#### TRANSMITTAL OF RESPONSES TO THE U.S. ENVIRONMENTAL PROTECTION AGENCY AND OHIO ENVIRONMENTAL PROTECTION AGENCY COMMENTS ON THE LEACHATE CONVEYANCE SYSTEM LEAK INVESTIGATION REPORT

**RESPONSES TO U.S. ENVIRONMENTAL PROTECTION AGENCY COMMENTS  
ON THE ON-SITE DISPOSAL FACILITY  
LEACHATE TRANSMISSION SYSTEM LEAK INVESTIGATION REPORT**

**RESPONSES TO OHIO ENVIRONMENTAL PROTECTION AGENCY COMMENTS  
ON THE ON-SITE DISPOSAL FACILITY (OSDF)  
LEACHATE CONVEYANCE SYSTEM (LCS) LEAK INVESTIGATION REPORT**

PROJECT NO. C00573-3.2 FIGURE NO. 4-1  
DOCUMENT NO. F9930006 FILE NO. F99-A171.DWG

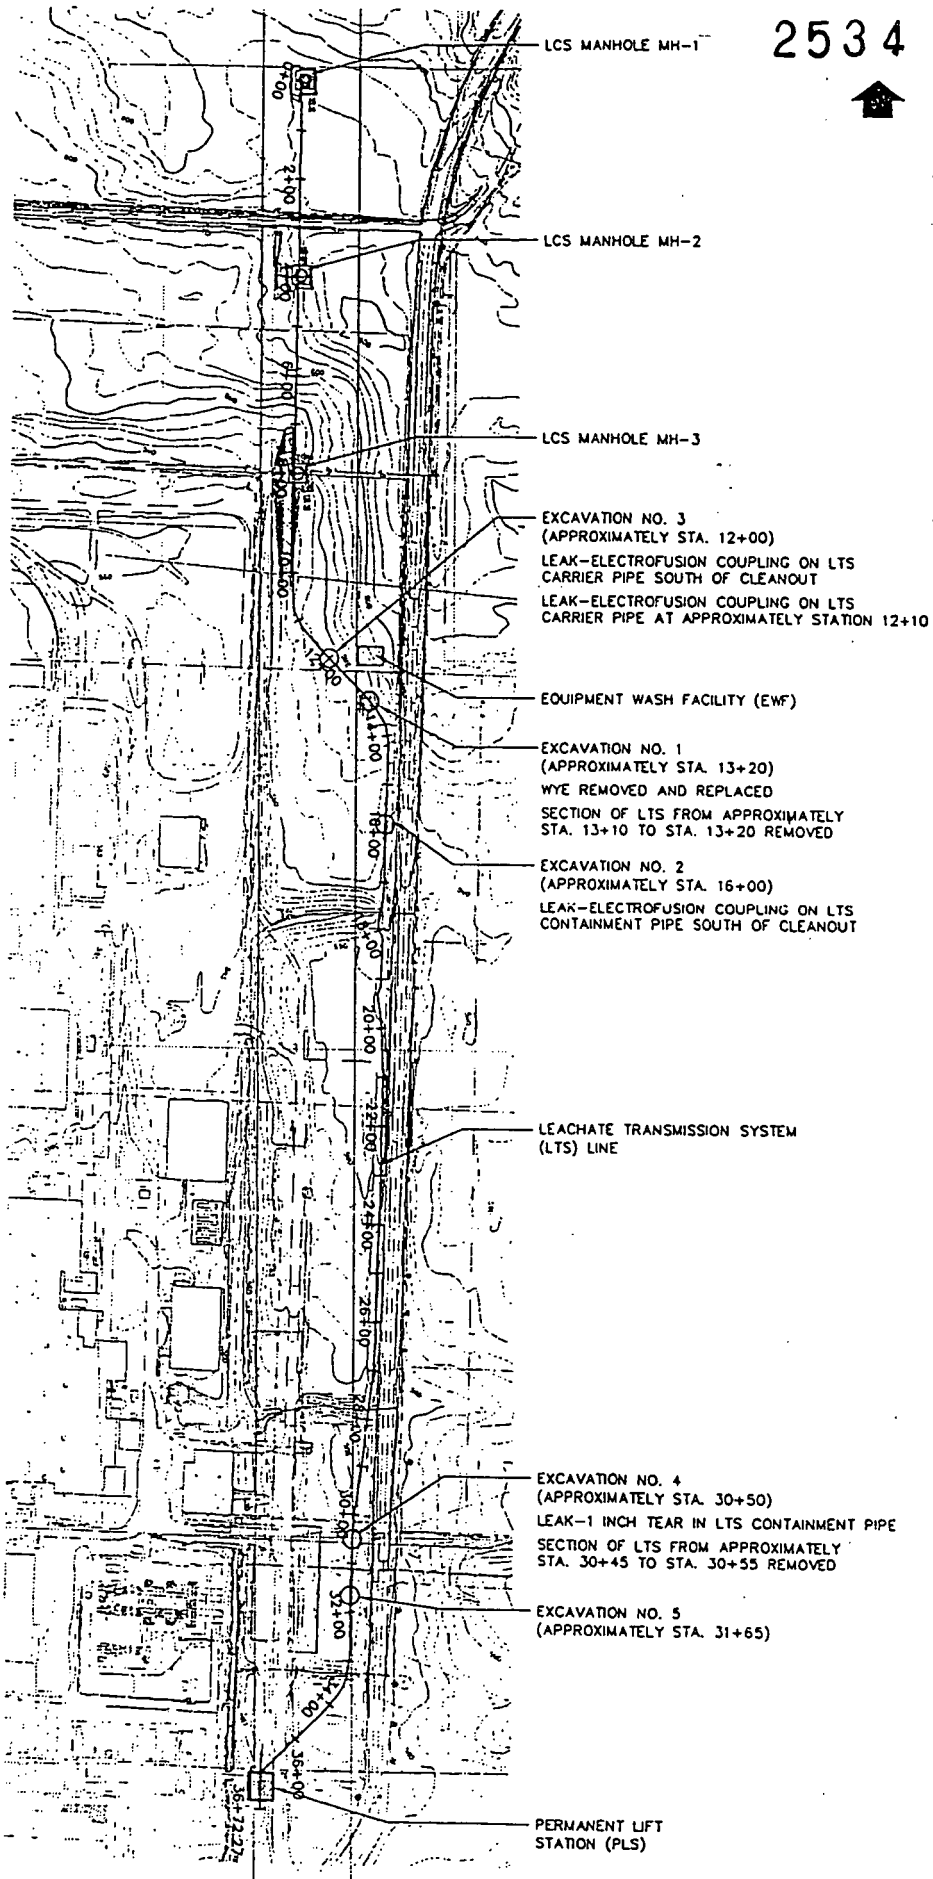
The soil samples were taken in Excavations 1 through 4. The samples were taken from the wall of each excavation from the clay layer just below the sand fill 6 to 12 inches beneath the pipe line. Refer to Figure 4-1 from the GeoSyntec Report (attached) for the locations of the excavations.

The Leak Investigation Report identified four leaks. Leak 1 was at a 10-inch electrofusion coupling on the containment pipe located in Excavation 2. Leak 2 was at a 6-inch electrofusion coupling on the carrier pipe located in Excavation 3. Leak 3 was a tear in the 10-inch containment pipe wall located in Excavation 4. Leak 4 was at a 6-inch electrofusion coupling on the carrier pipe located in Excavation 3. No leaks were identified in Excavation 1 nor in Excavation 5.
